DRB RECOMMENDATION MEETING

## The 8 Tower Seattle, WA

3025536

CARON REF #2016.049

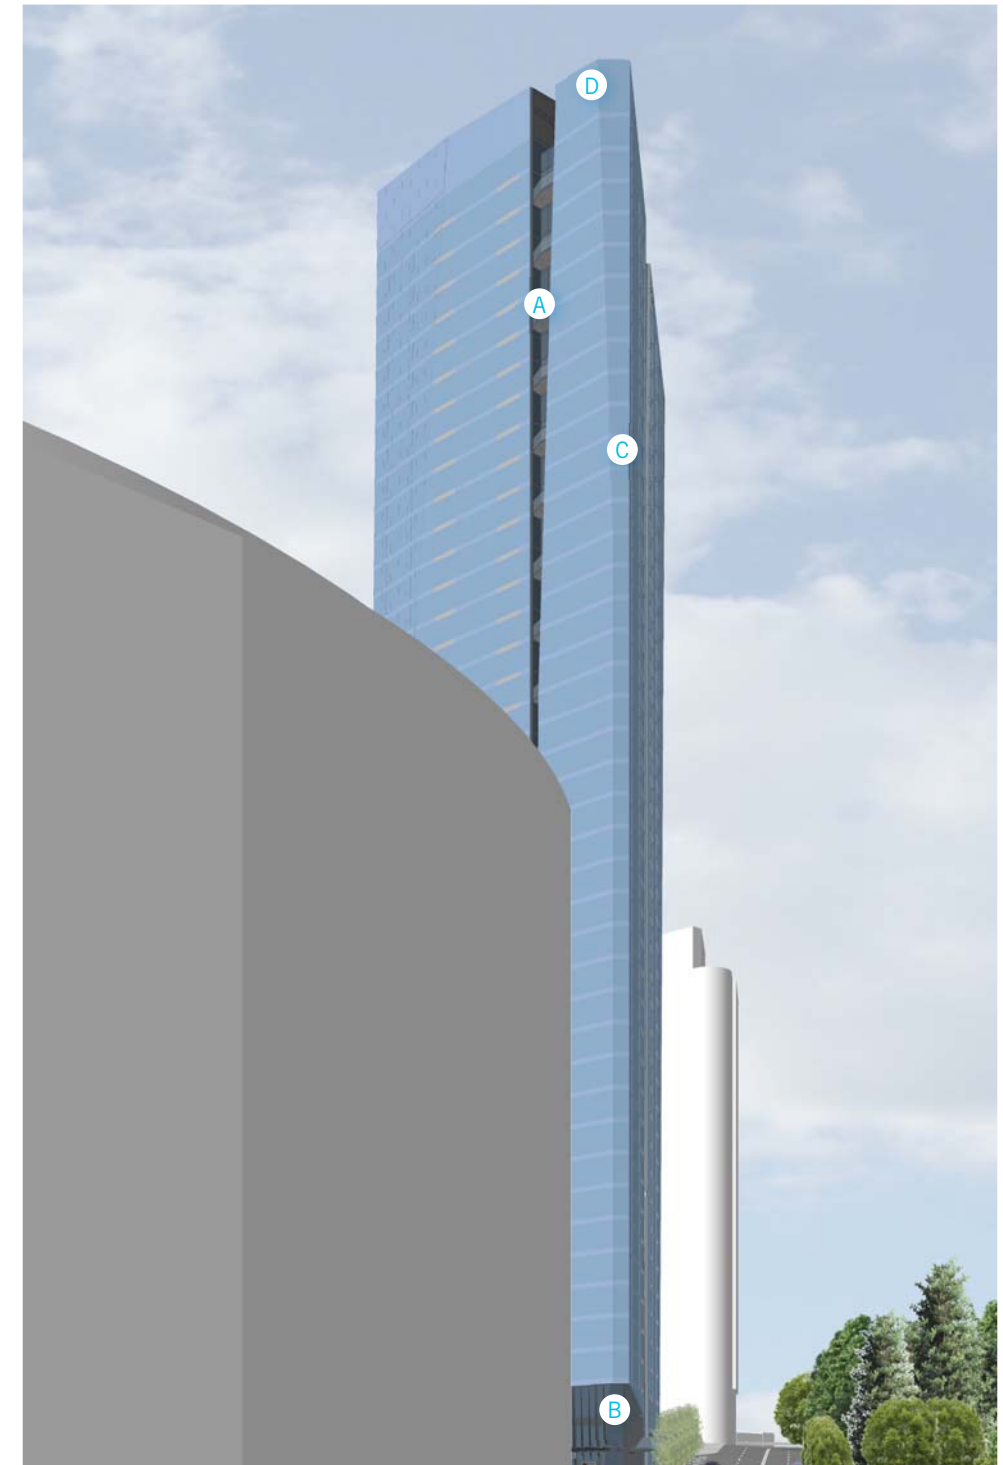
- 1. Massing and Architectural Concept.
- The Board acknowledged that they reviewed an interesting and challenging design concept at the first EDG and wanted to see that concept fully embraced at this stage, with that concept more clearly expressed throughout the building elevations, base and top (A2, B4).

The applicant revised the overall massing of the building to retain principals of massing and modulation from the original concept while eliminating the rounded corners. These are expressed on building facades, base and roof top. The language of eroded angular shapes with irregularity in location and form, peeled back exterior skin and tower meeting the sidewalk plane is consistently applied to entire building form. The concept of a sculpted monolith with vertical modulation help define a well-balanced building form.

DRB DESIGN REFINEMENT: NORTH ELEVATION

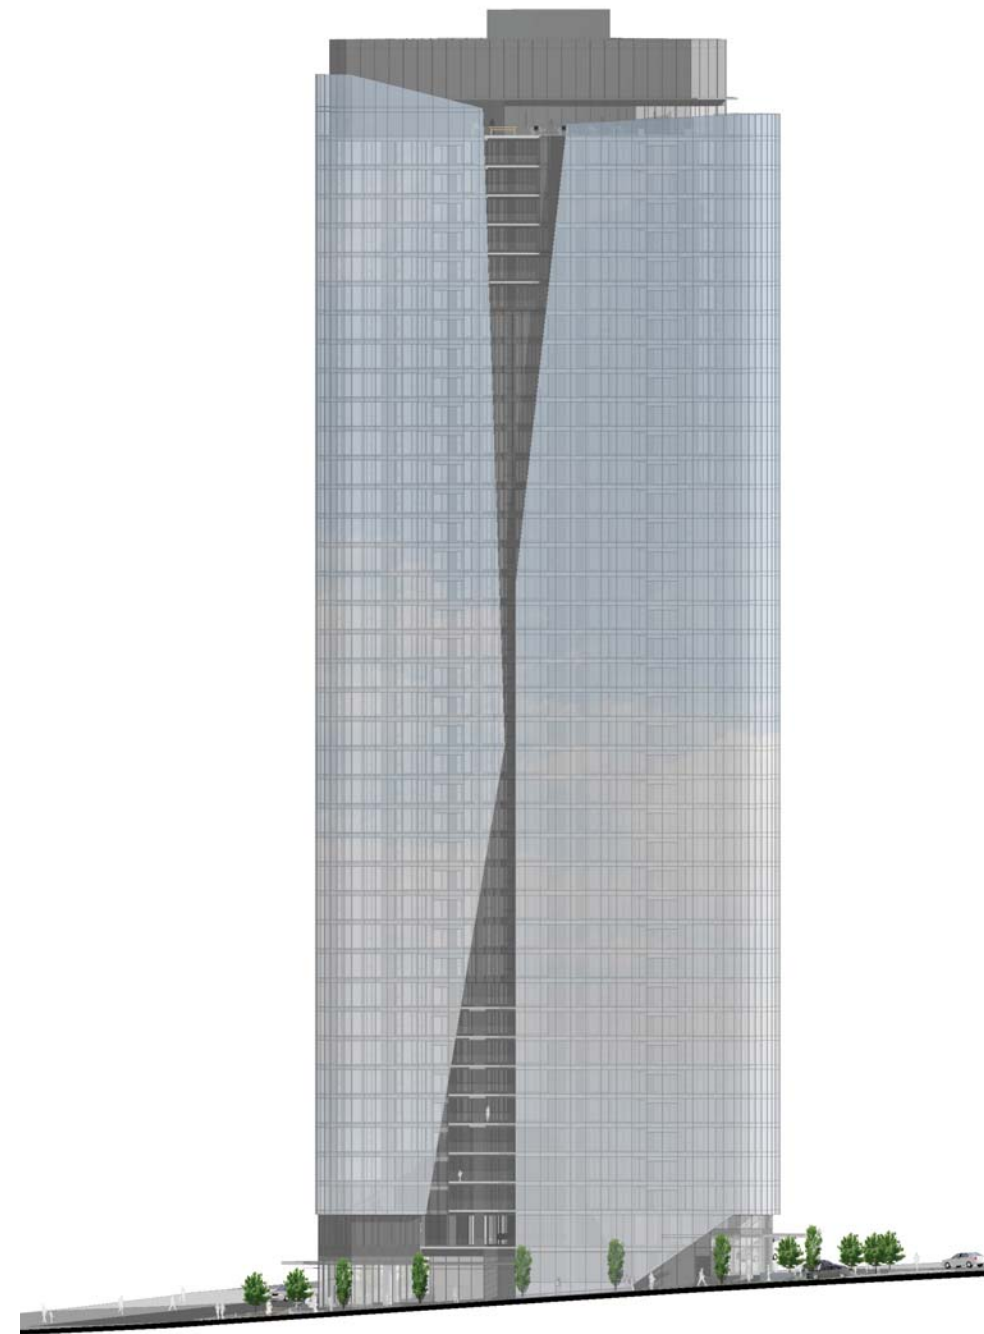
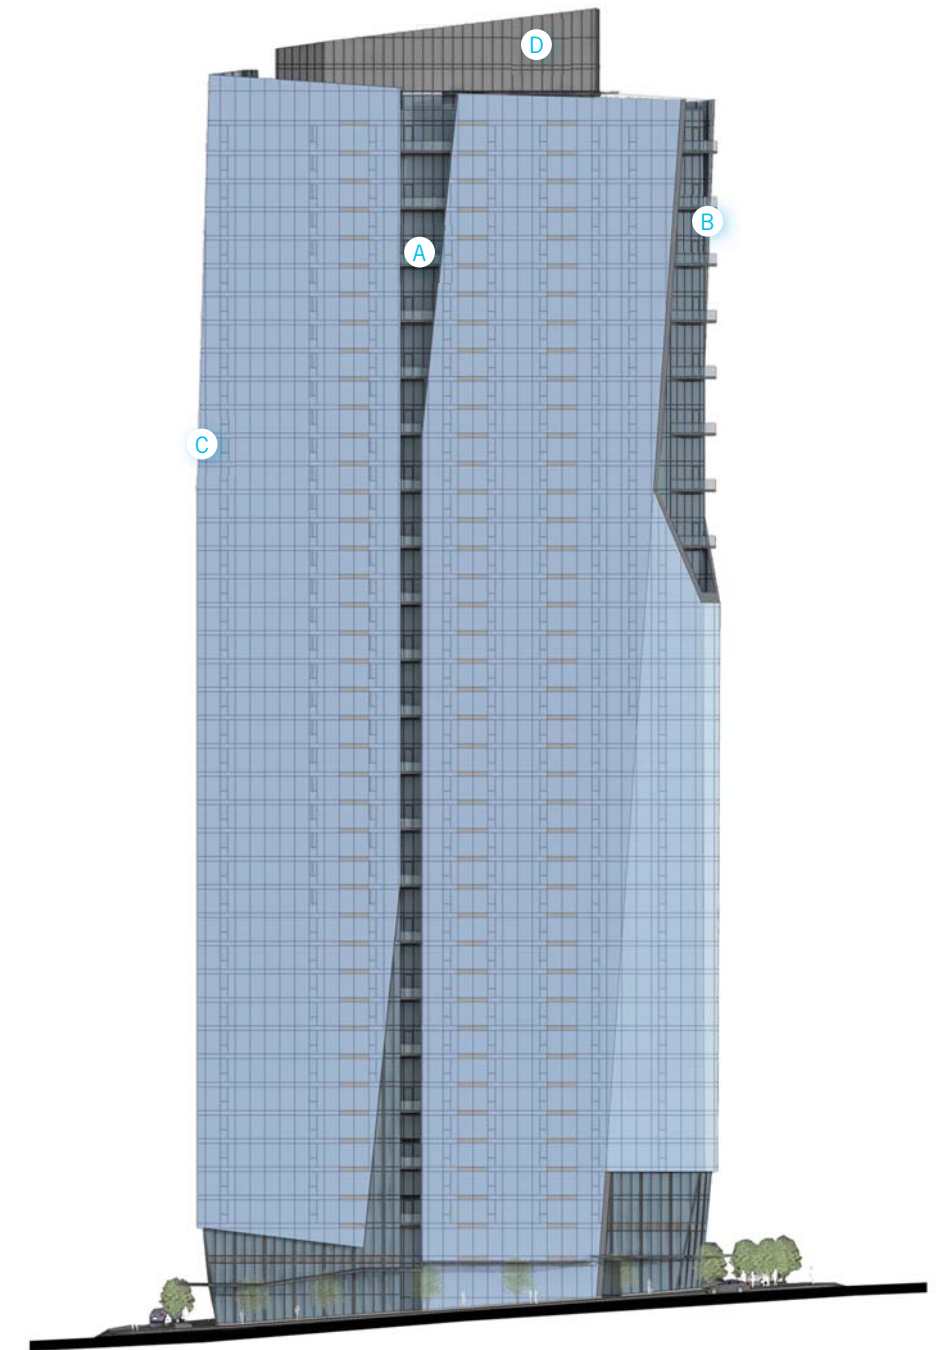
1. Massing and Architectural Concept.
  - The Board noted that the eroded shapes of the base and top reinforced and related to each other in both plan view and the elevation views.
  - The Board felt the building base has been successfully resolved where the podium has been eliminated and instead the tower concept extends directly to the sidewalk creating a more dramatic and elegant solution consistent with the design concept. The Board was also very supportive of the irregular and dramatic base design, where the building skin appears to peel back in organic, angular forms (A2, B4).
  - The Board was also very pleased with the design of the building top, clearly expressing the chard-like language (A2).
  - The Board emphasized that the pushing down at the top and peeling up of the skin at the base were very successful (A2, B4)

Based on this guidance, the applicant has developed the building form that reinforces the overall geometry in both plan views and elevation views. The proposal maintains the eroded and modulated base as well as sculpted top of the tower; the reliefs (fissures) are edited and one was added on the Bell street facade.

DRB DESIGN REFINEMENT: SOUTHWEST ELEVATION

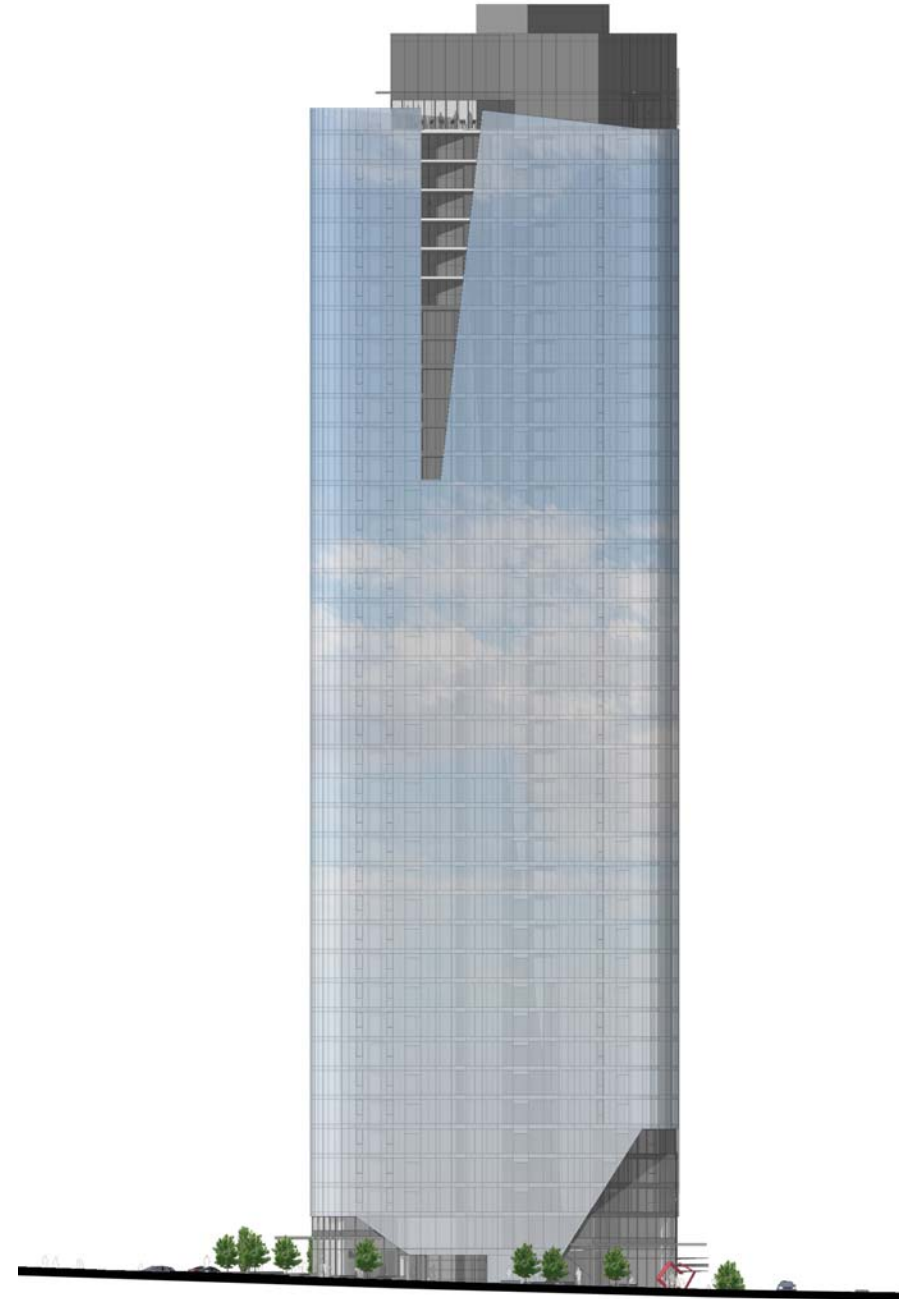
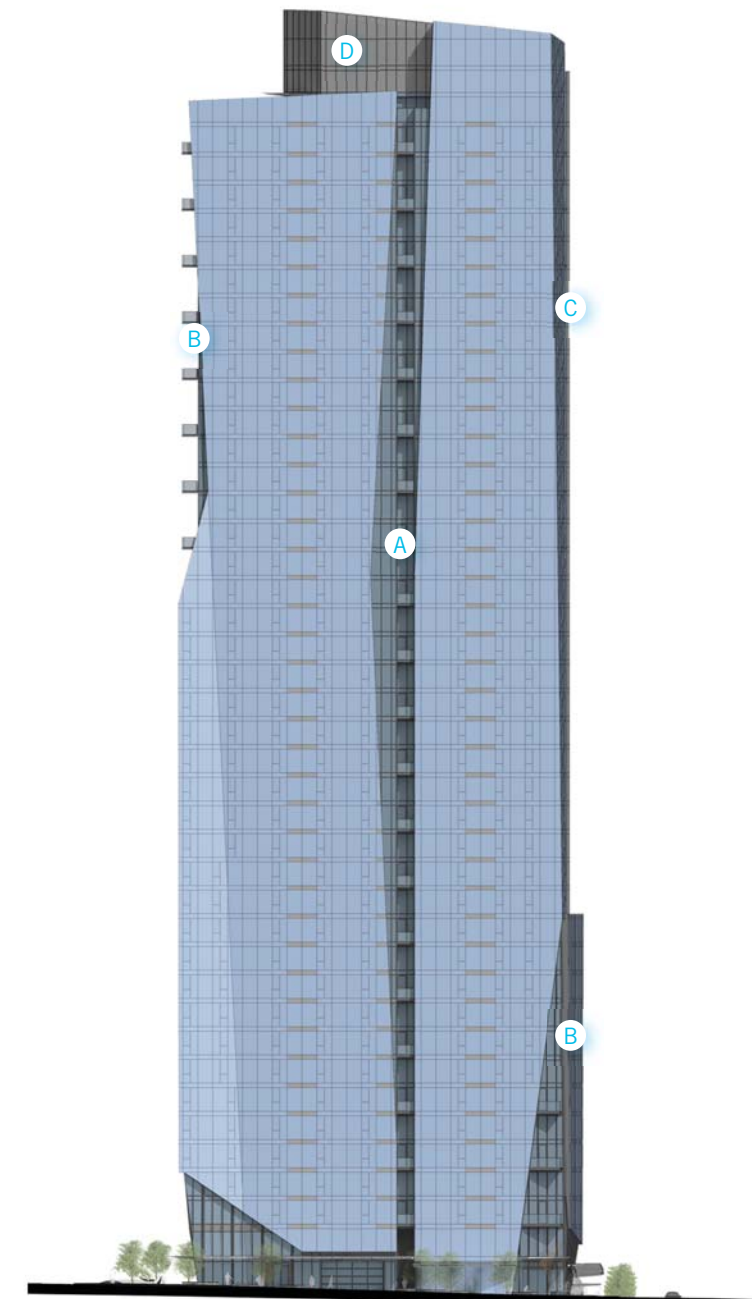
1. Massing and Architectural Concept.
  - The Board noted that the eroded shapes of the base and top reinforced and related to each other in both plan view and the elevation views.
  - The Board felt the building base has been successfully resolved where the podium has been eliminated and instead the tower concept extends directly to the sidewalk creating a more dramatic and elegant solution consistent with the design concept. The Board was also very supportive of the irregular and dramatic base design, where the building skin appears to peel back in organic, angular forms (A2, B4).
  - The Board was also very pleased with the design of the building top, clearly expressing the chard-like language (A2).
  - The Board emphasized that the pushing down at the top and peeling up of the skin at the base were very successful (A2, B4)

Based on this guidance, the applicant has developed the building form that reinforces the overall geometry in both plan views and elevation views. The proposal maintains the eroded and modulated base as well as sculpted top of the tower; the reliefs (fissures) are edited and one was added on the Bell street facade.

DRB DESIGN REFINEMENT: SOUTHEAST ELEVATION

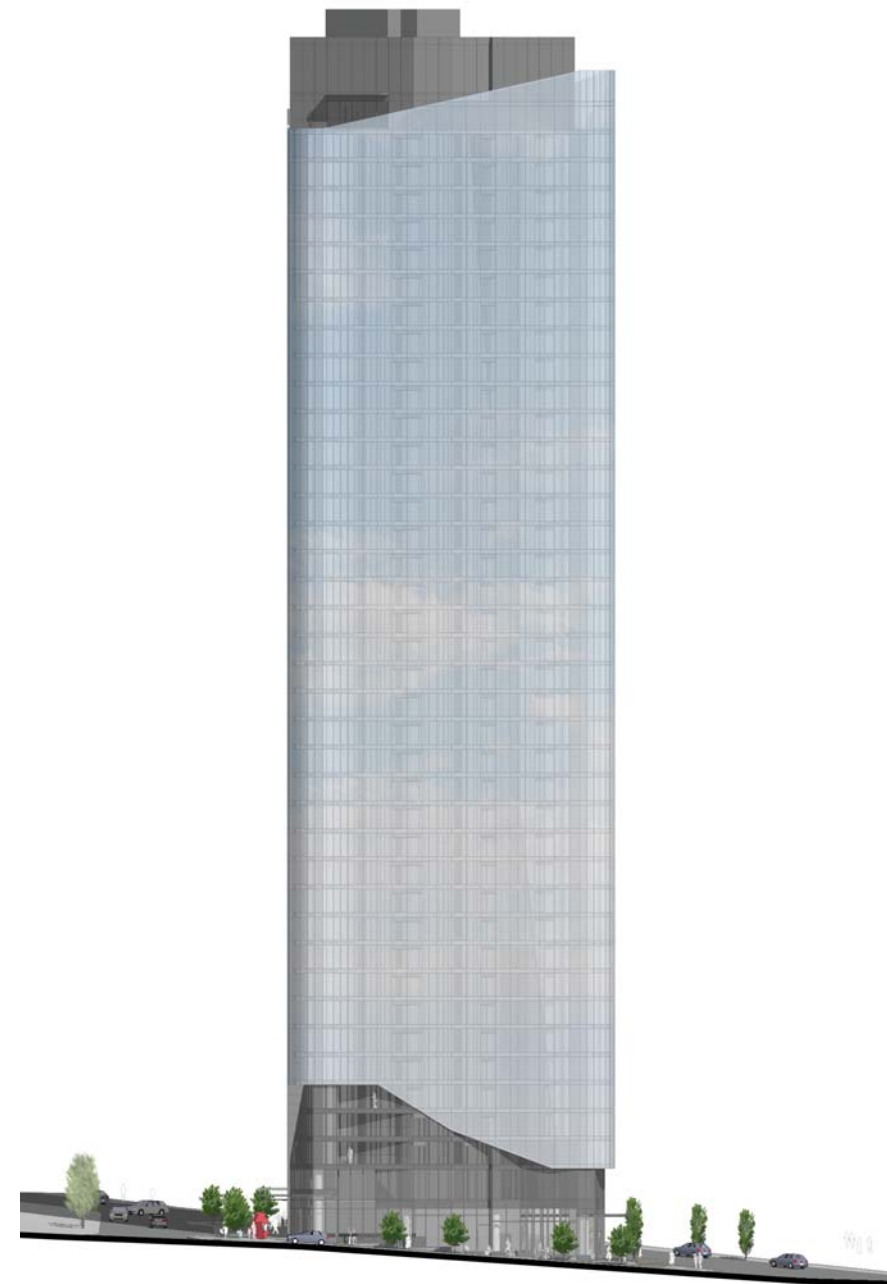
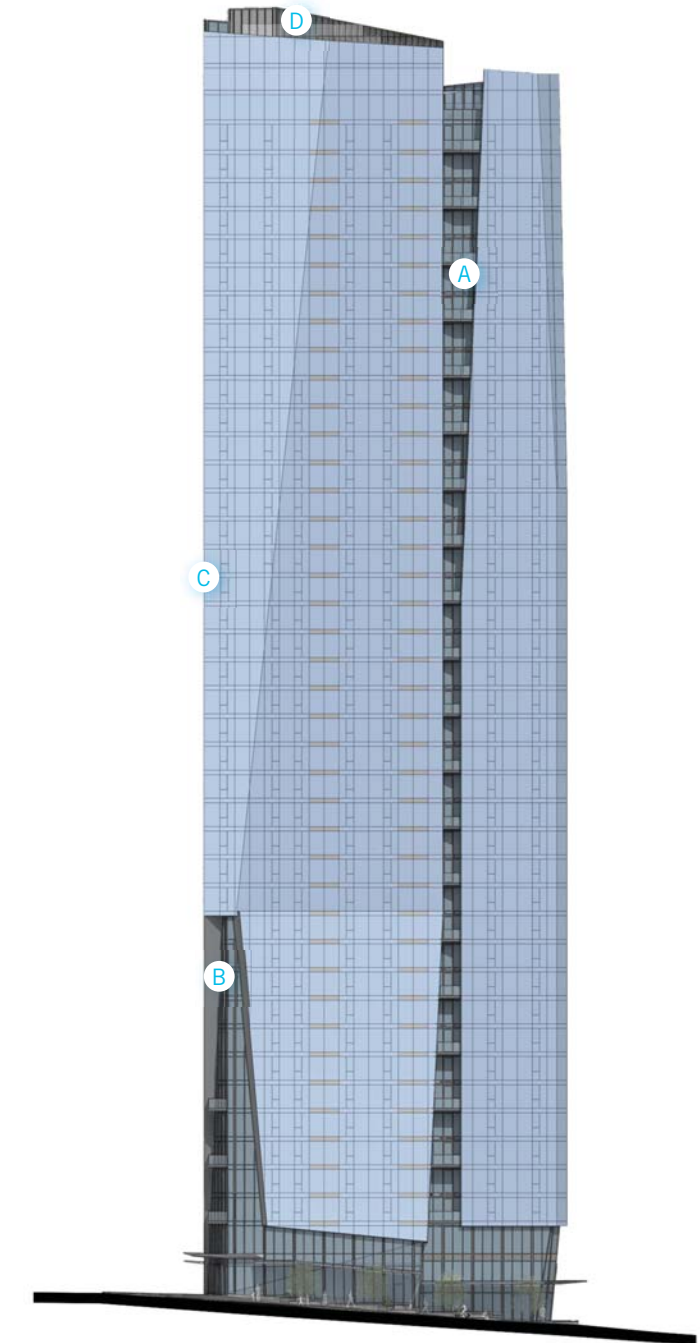
1. Massing and Architectural Concept.
  - The Board noted that the eroded shapes of the base and top reinforced and related to each other in both plan view and the elevation views.
  - The Board felt the building base has been successfully resolved where the podium has been eliminated and instead the tower concept extends directly to the sidewalk creating a more dramatic and elegant solution consistent with the design concept. The Board was also very supportive of the irregular and dramatic base design, where the building skin appears to peel back in organic, angular forms (A2, B4).
  - The Board was also very pleased with the design of the building top, clearly expressing the chard-like language (A2).
  - The Board emphasized that the pushing down at the top and peeling up of the skin at the base were very successful (A2, B4)

Based on this guidance, the applicant has developed the building form that reinforces the overall geometry in both plan views and elevation views. The proposal maintains the eroded and modulated base as well as sculpted top of the tower; the reliefs (fissures) are edited and one was added on the Bell street facade.

##### 2. Bell Street Elevation

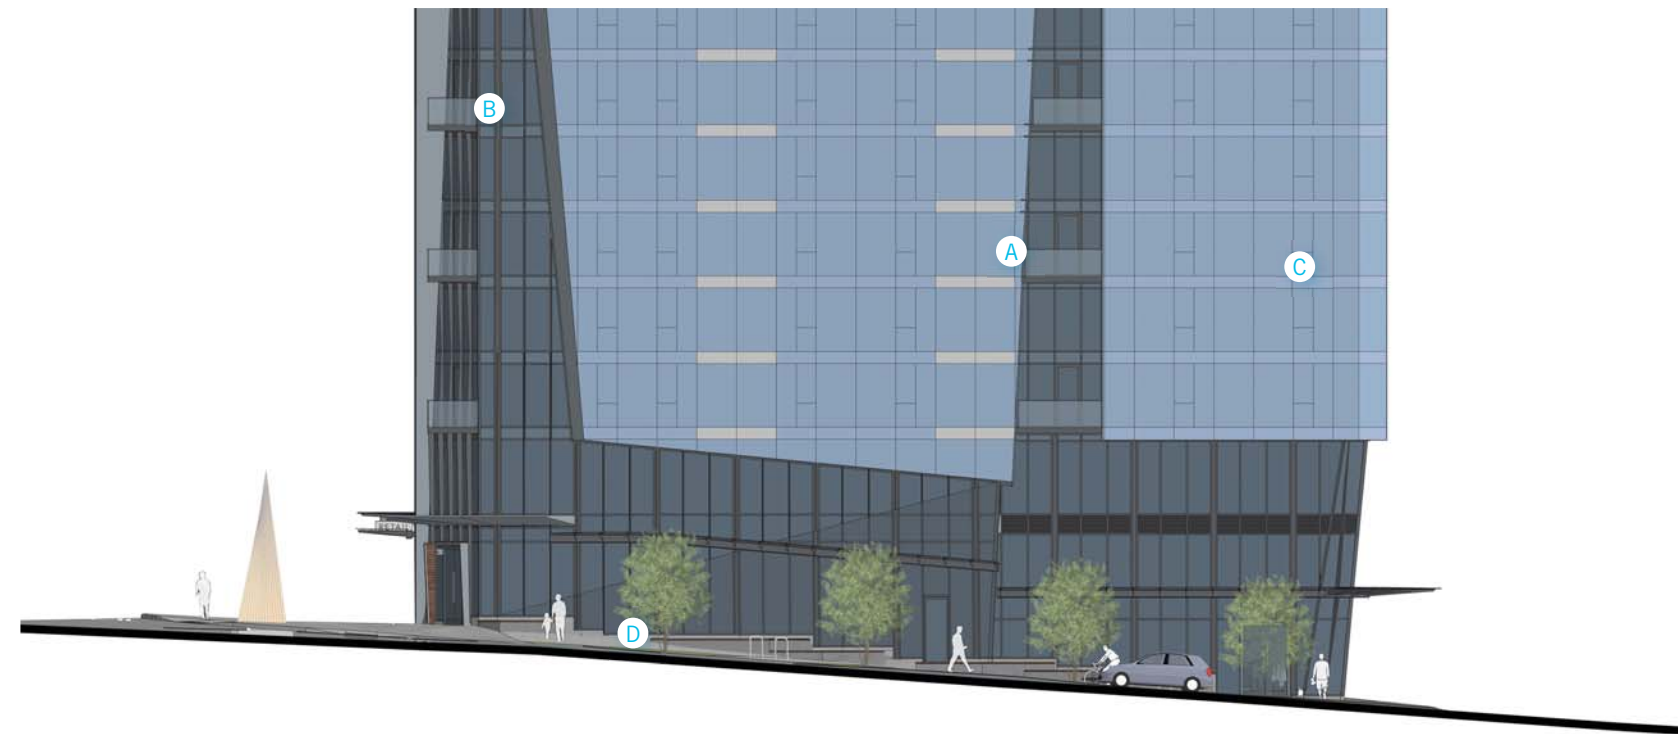
- As discussed above in the discussion of the tower design, the Board focused on the Bell Street tower elevation specifically noting that this elevation needed greater attention integrating the 'fissure' design concept fully on this elevation. This treatment should provide the modulation that is intended (and reiterated by the Board's guidance) on the other two elevations (A2, B4).
